Access Compliance Report Public Rights-of-Way (Curb Ramps)

Main Street: ORANGE_TREE_LN		Cross Street: PROSPECT_AVE		Location:	NW
ADA ID: RPRK220121140819	Ramp Type: Type 4 - Parallel	Initial Pass/Fail: Fail	Overall Compliance: No	Severity Score:	15
Codes/Mitigation Info/Possible Solution			Field Measurements/Component Compliance

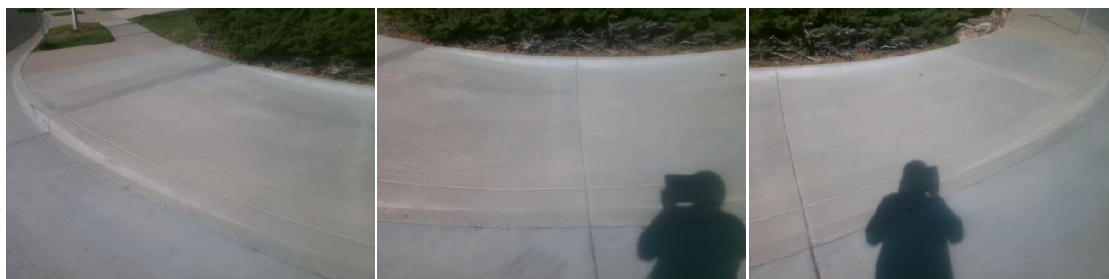
R204.3, R304.5.3, STD 1115

Remove & Replace Curb Ramp With Two New Directional Ramps or Equivalent.
